Comment Set E.4: Applicant – Description of Proposed Project/Action and Alternatives

ANTELOPE-PARDEE 500kV TRANSMISSION PROJECT SCE COMMENTS & SUGGESTED REVISIONS ON DEIR/DEIS DESCRIPTION OF PROPOSED PROJECT/ACTION AND ALTERNATIVES

October 2006

E.4-12 cont'd

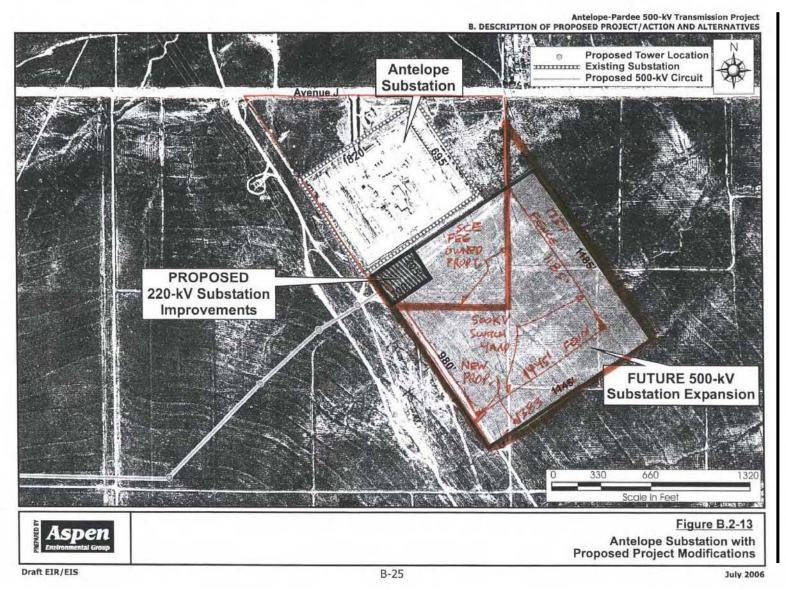
12	B.2-13	B-25	Мар	Figure B.2-13 is incorrect.	The figure should be modified to reflect that the 220 kV improvements are within existing SCE owned property. (See modified figure attached)	E.4-
13	B.2.2	B-27 throug h B-29	Tables B.2-3 and B.2-4	These 2 tables are confusing because it uses check marks instead of numbers.	SCE recommends using the tables provided in the PEA.	E.4-1

- E.4-10 Section B.2.1.2, under "Pardee Substation", has been updated.
- E.4-11 See the response to Comment E.4-3 regarding construction duration.
- E.4-12 Figure B.2-13 has been updated.
